Access Compliance Report

Public Rights-of-Way

(Curb Ramps)

Intersection ID: 27404	Main Street: BALLANTYNE COMMONS PY	Cross Street: MEADOW RUN LN	Location: NW
ADA ID: 693D2014DABE	Ramp Type: Perp	Initial Pass/Fail: Fail	Overall Compliance: No
Severity Score: 21.25			
Codes/Mitigation Info/Possible Solution		Field Measurements/Component Compliance

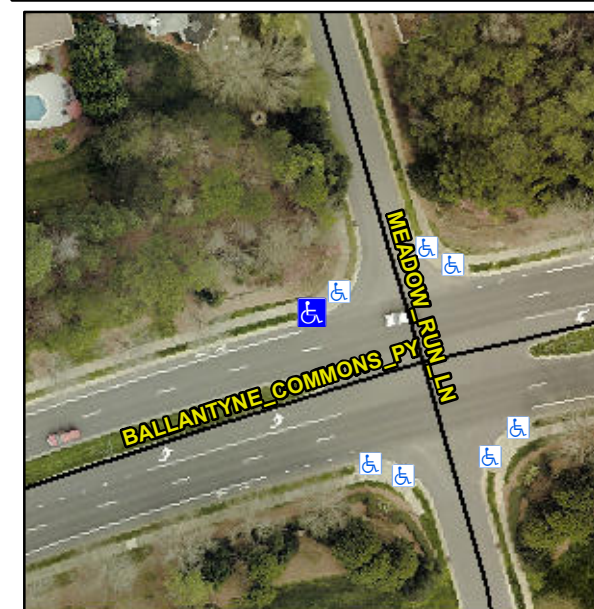
Not Found, R304.5.1, R304.2.2

Compliance	Description	Data	Compliance	Description	Data
N/A	Ramp Length (in)	47.0	No	Ramp Slope (%)	8.4
No	Ramp Width (in)	43.0	Yes	Ramp XSlope (%)	1.0
N/A	Flare Type LT	N/A	N/A	Flare Type RT	N/A
N/A	Flare Slope LT (%)	N/A	N/A	Flare Slope RT (%)	N/A
N/A	Flare Traversable LT?	N/A	N/A	Flare Traversable RT?	N/A
N/A	Landing Length (in)	N/A	N/A	DWS Provided?	N/A
N/A	Landing Width (in)	N/A	N/A	DWS Contrast?	N/A
N/A	Landing Slope (%)	N/A	N/A	DWS Length (in)	N/A
N/A	Landing X Slope (%)	N/A	N/A	DWS Full Width?	N/A
N/A	Landing Curb? (Y/N)	N/A	N/A	DWS Offset (in)	N/A
N/A	Shared Landing?	N/A			
N/A	Gutter Ponding?	N/A	N/A	Gutter Slope (%)	N/A
N/A	Gutter Lip Ht (in)	N/A	N/A	Gutter X Slope (%)	N/A
N/A	Painted X Walk1?	No	N/A	Painted X Walk2?	N/A
	X Walk 1 Direction	To S		X Walk 2 Direction	N/A
N/A	X Walk 1 Width (in)	N/A	N/A	X Walk 2 Width (in)	N/A
	X Walk 1 Slope (%)	3.2		X Walk 2 Slope (%)	N/A
	X Walk 1 X Slope (%)	0.1		X Walk 2 X Slope (%)	N/A

Remove & Replace Entire Ramp.
